City of Carpinteria
Architectural Review Board Agenda
Thursday, March 12, 2026
Council Chamber, 5775 Carpinteria Avenue,
Carpinteria, CA 93013

1. Project: Aliso School Kindergarten Building, Project #25-2329-DP/CDP/ARB
Address: 4545 Carpinteria Avenue
Applicant: Jason Kaff, CUSD Assistant Superintendent
Planner: Megan Musolf

Request of Robert Robles, agent and architect, for Jason Kaff, Carpinteria Unified School District Assistant Superintendent, for final review of a proposed new kindergarten classroom building. The proposed building would replace the five portable structures removed from the site. The building would be 6,467 square feet and would consist of four classrooms, one staff and five student restrooms, and a raised courtyard area. The maximum height of the new building would be 27 feet 10 inches. Existing playgrounds would remain. The adjacent parking area would be partially re-striped to accommodate ADA-compliant parking spaces and the required fire truck turning radius, resulting in a net loss of five spaces. New landscape and hardscape would be installed around the proposed building. The project site, Aliso School campus, is 7.79 acres, zoned Community Facility (CF

PLANTING PLAN

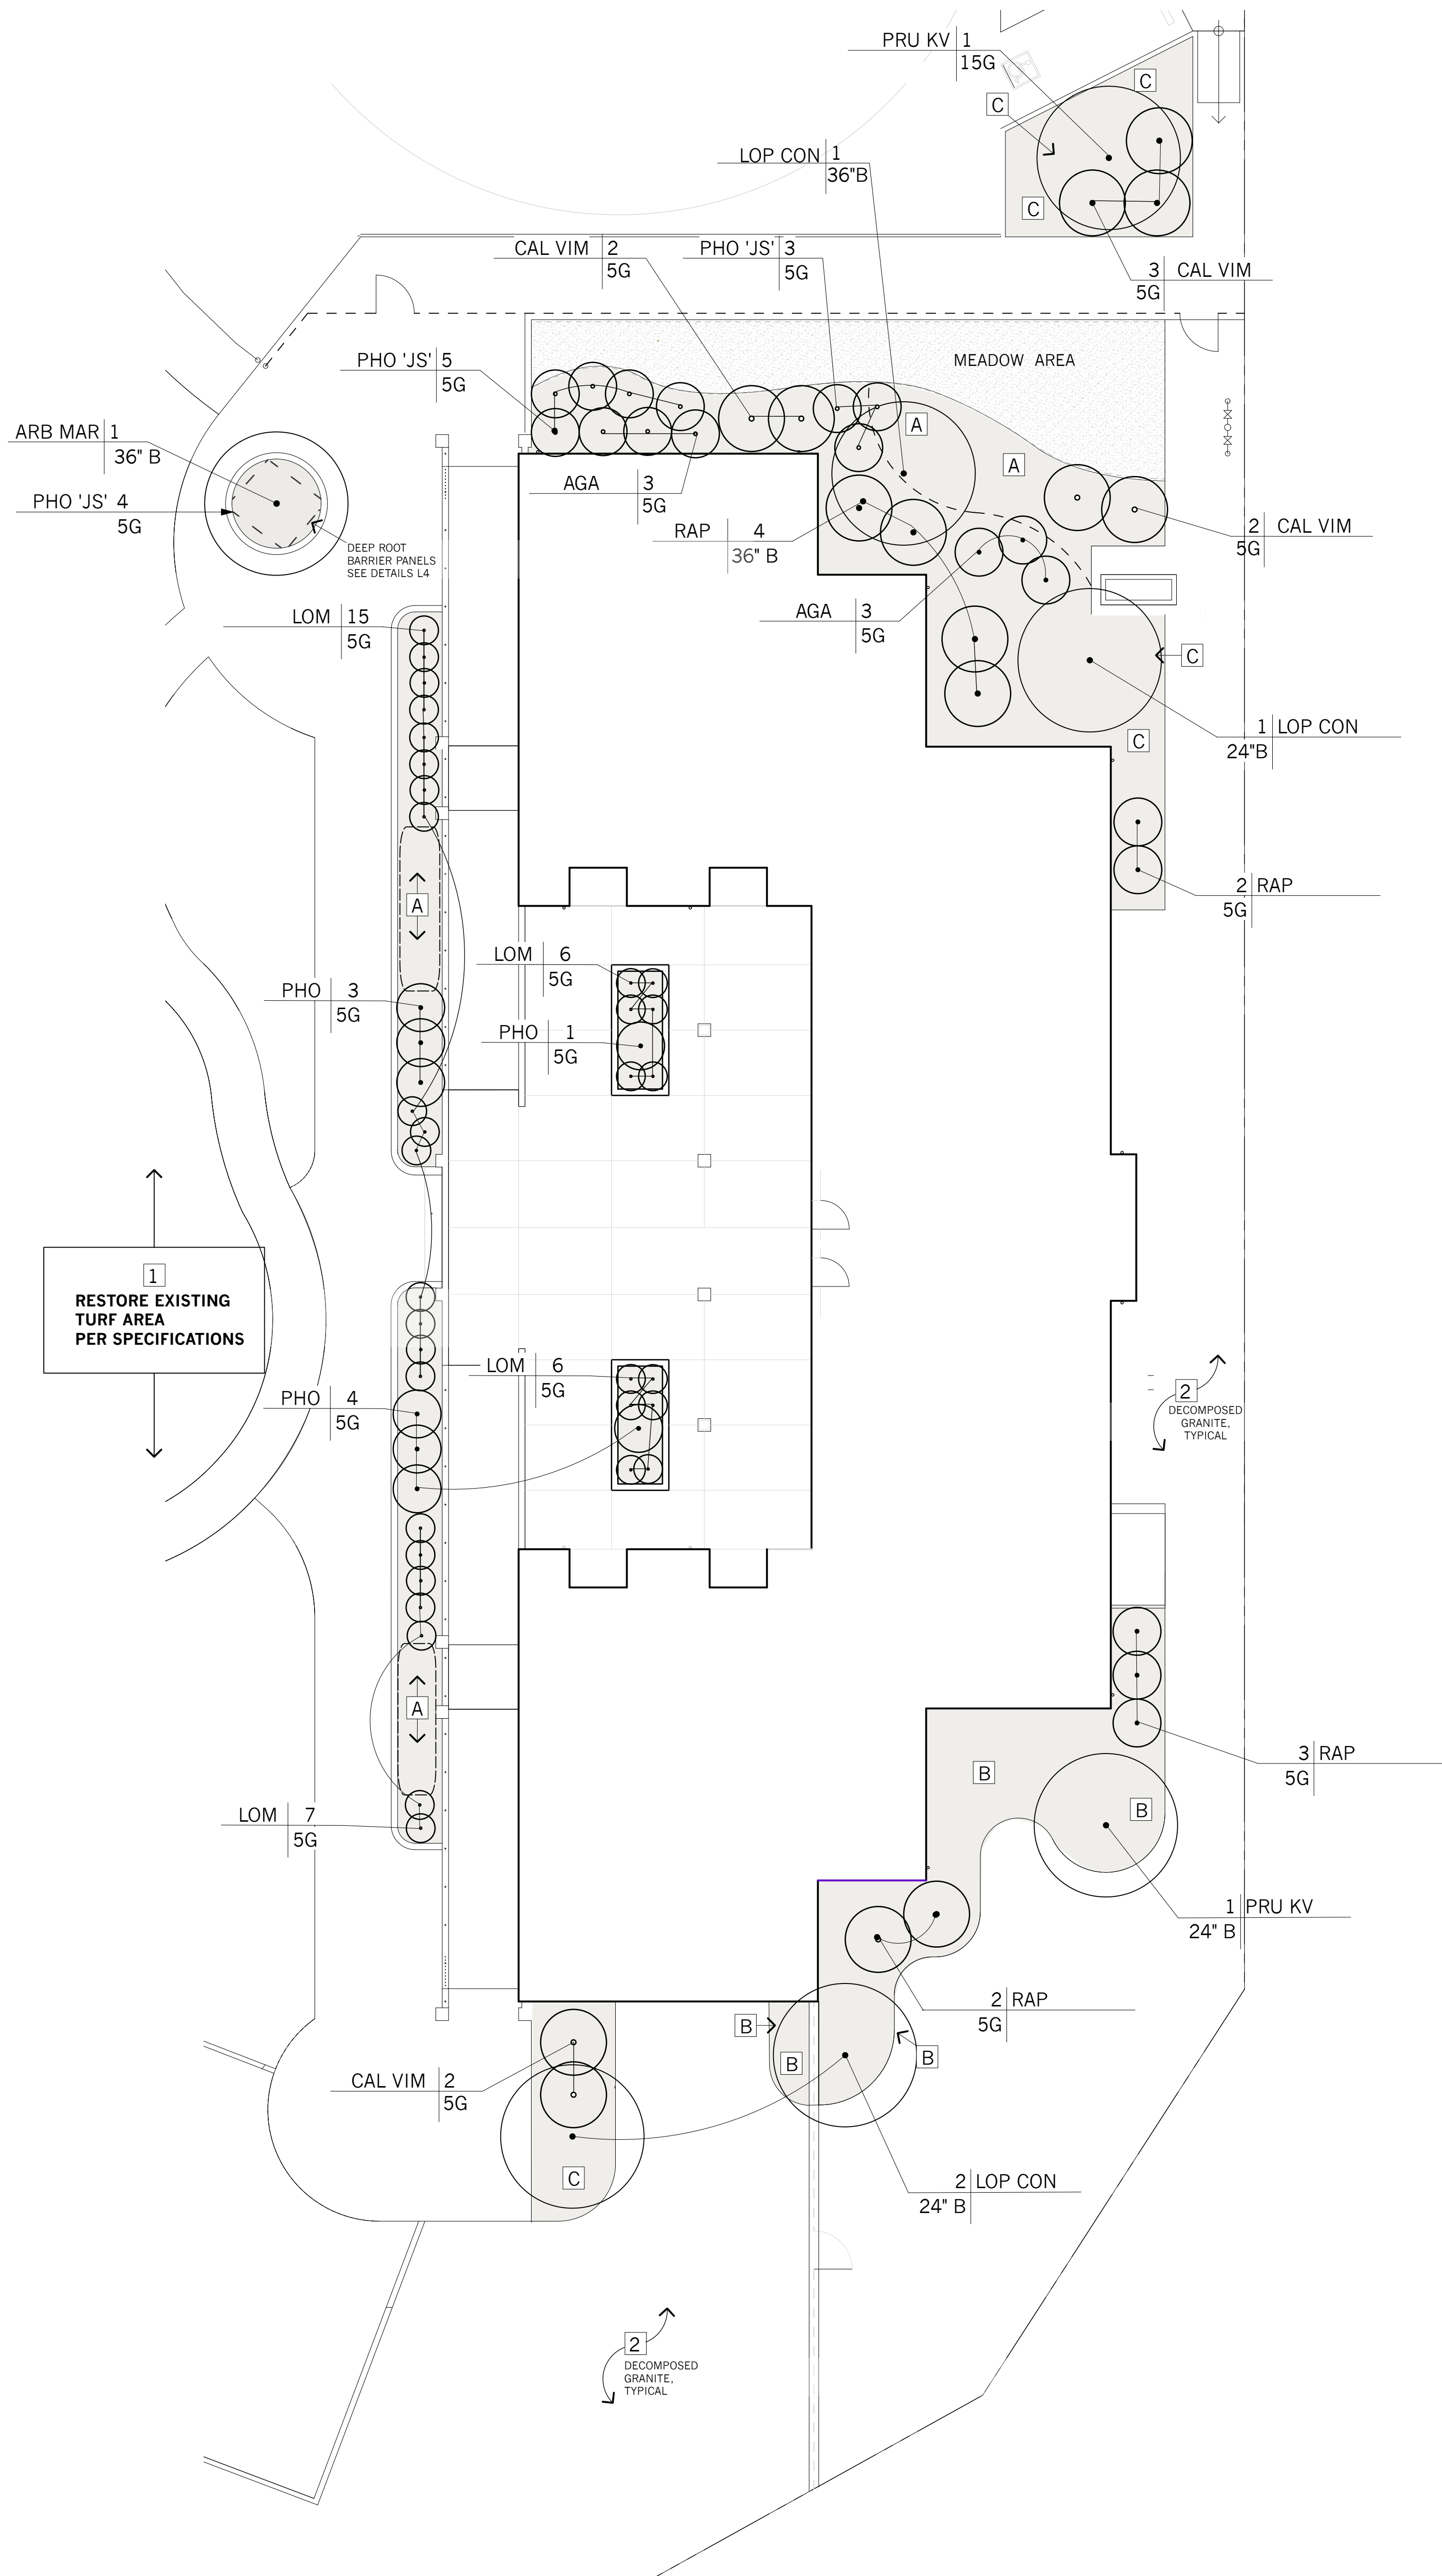
Comments on plant choices: Tipuana tipu trees damage pavement, Chinese evergreen elms drop considerable litter, coral bells are easily trampled by children, and marine blue sage look “leggy” after blooming (recommended a more “self-cleaning” plant).

In response, Tipuana tipu and Chinese evergreen elm trees were removed from the landscaping plan, and Marina arbutus and Brisbane box trees were added. The sage shrubs were also removed, and replaced with dwarf bottlebrush (see Attachment A Sheet L2). The applicant opted to maintain the coral bells, noting that they would only be planted in raised planters, along the ramp frontage, or on the rear side of the building, placing them outside the pedestrian path of travel and unlikely to be stepped on. The applicant additionally confirmed that all selected plants are drought-tolerant and low-maintenance, and have been reviewed and approved by CUSD. Ongoing, seasonally appropriate maintenance will remain part of campus operations.

SHEET TITLE:
**EXTERIOR
ELEVATIONS**
SHEET NUMBER:
A3.0
OF

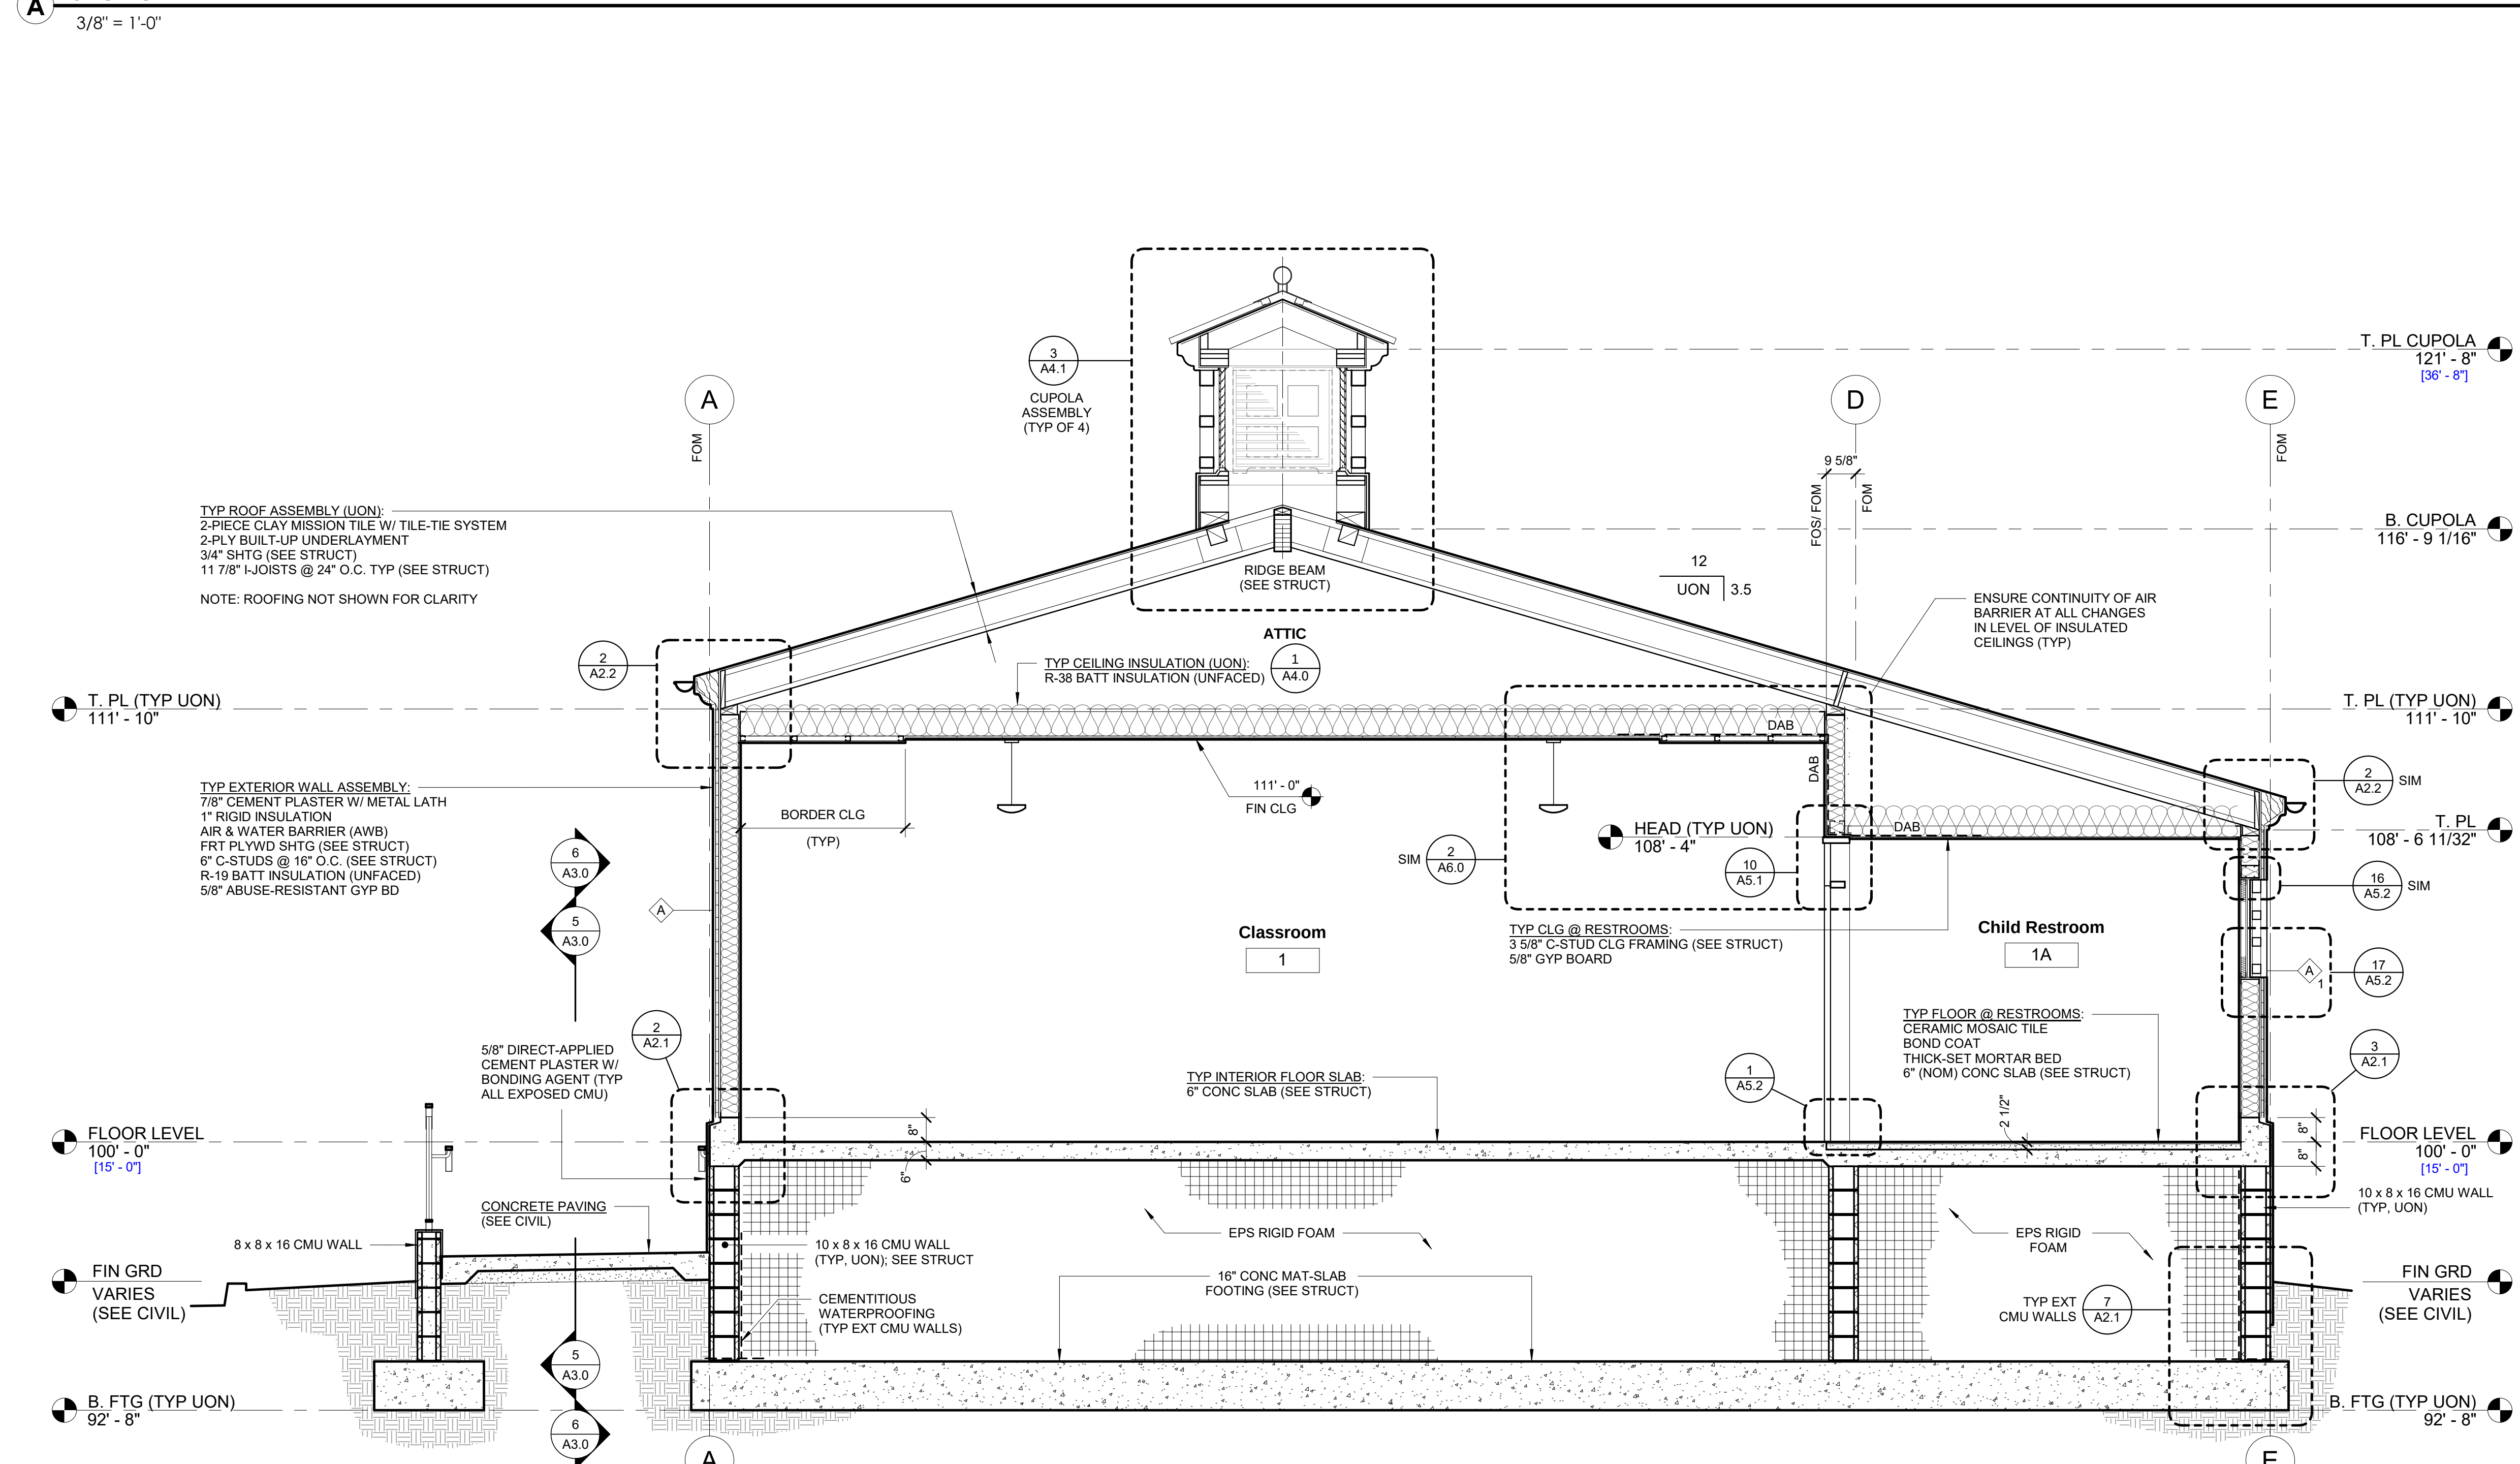
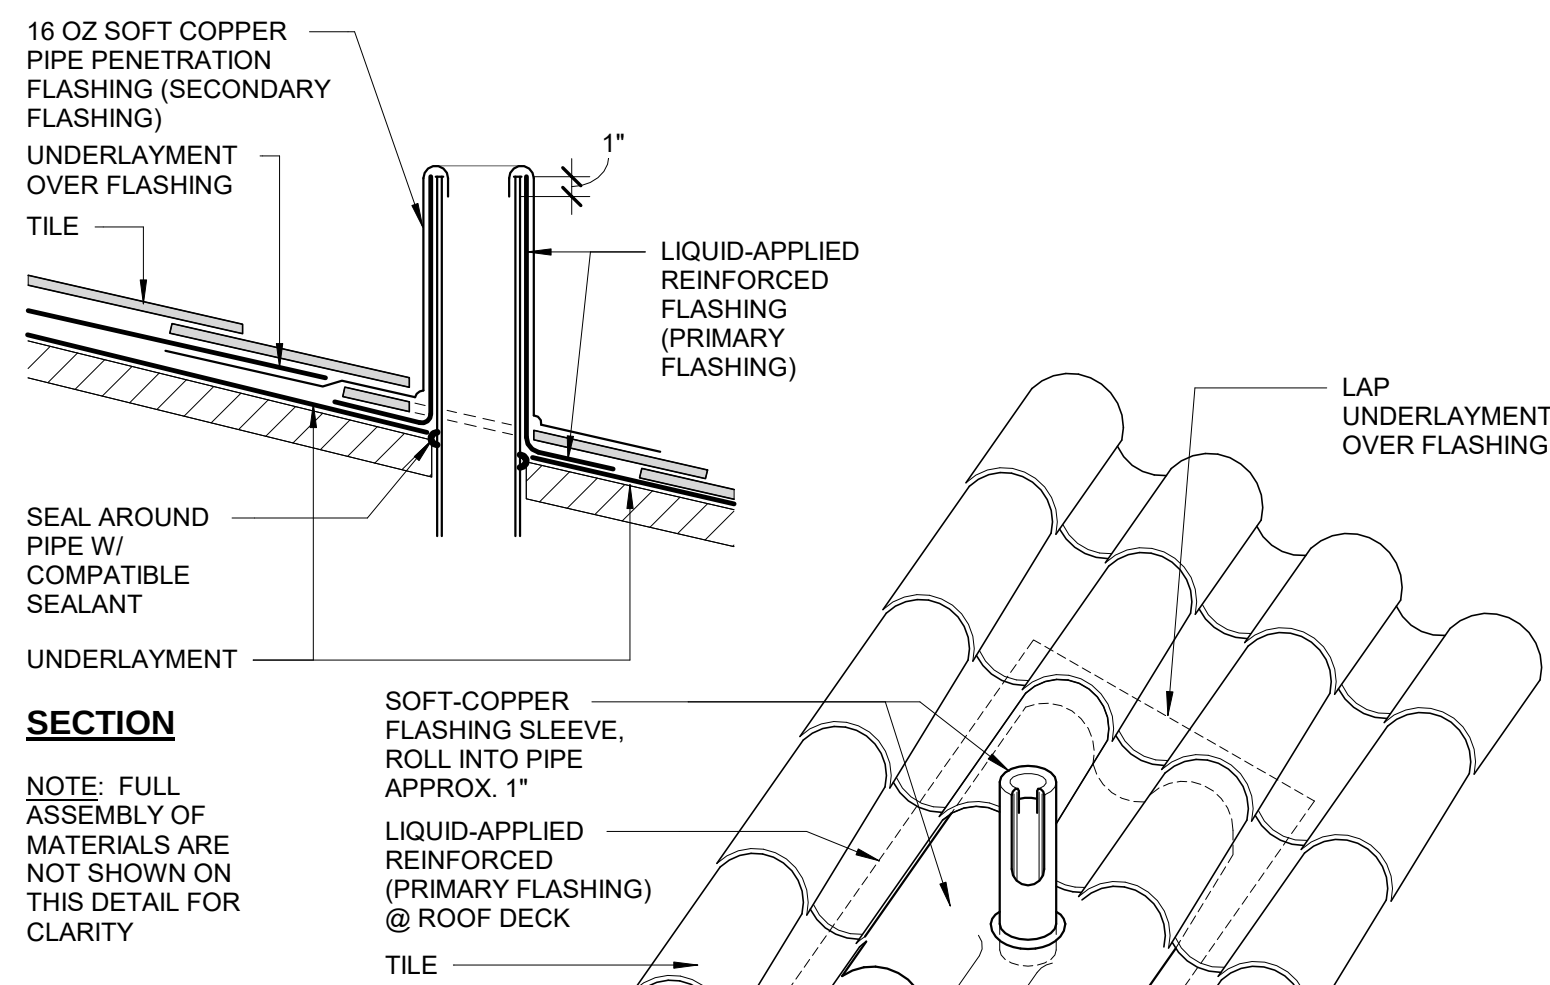
ARB members noted the building felt “institutional,” “bulky,” and “sterile.” Suggested to soften the building’s appearance— recess the windows more, add trim or tile around them, place a tile pattern on blank façades, or incorporate other small architectural details that would not greatly increase the project cost. Incorporate more “whimsy,” for a building meant for young children.

In response, cornices and corbels have been added to the top of the large windows on the west elevation and the two outermost windows on the east elevation, reducing the “sterile” feel (see Attachment A Sheet A 3.0). A tile pattern with green and brown tones was added to the west elevation between the windows, and at the front center of the ramp, helping to break up larger blank surfaces. Concrete grilles on the cupolas and bathroom windows, previously the same white color as the primary exterior paint, were switched to a terra-cotta color to match the roof and add more contrast.
